UNITED STATES PATENT AND TRADEMARK OFFICE

| APPLICATION NO. | FILING DATE | FIRST NAMED INVENTOR | ATTORNEY DOCKET NO. | CONFIRMATION NO. |
|---|-------------|----------------------|---------------------------------|-----------------------------|
| 10/501,345 | 07/26/2004 | Jeannot Hironimus | 255484US6PCT | 6095 |

| Office Action Summary | Application No. | Applicant(s) | |

DETAILED ACTION

fig 6-7: two offset raking disks capable to rotate about a horizontal axis & to form a truncated V & connected to supports on the main frame & friction driven & comprises circular support fitted with teeth (see drawings below; embodiment I outlined in dependent claims 17-21, 30, 32);

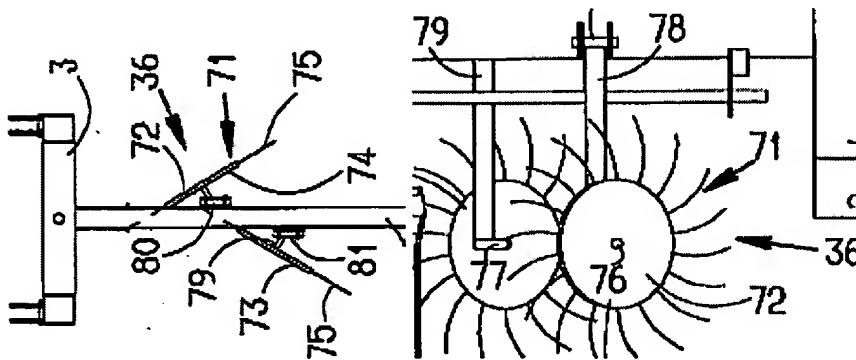
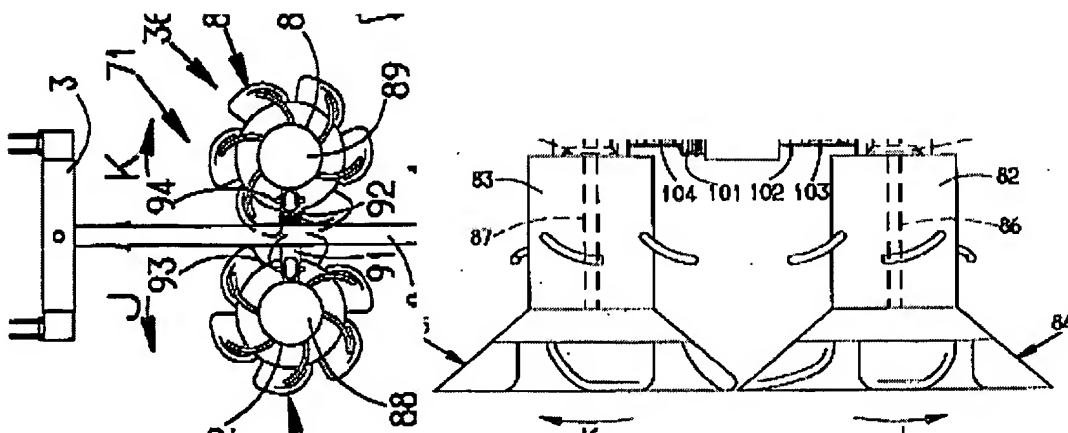
(3) One of ordinary skill could have replaced the windrow rakes 12 & 13 of Aron and applied the known alternative and/or substituted one known element (rakes) for another (pickup & swathing) and the results of the substitution would have been predictable.
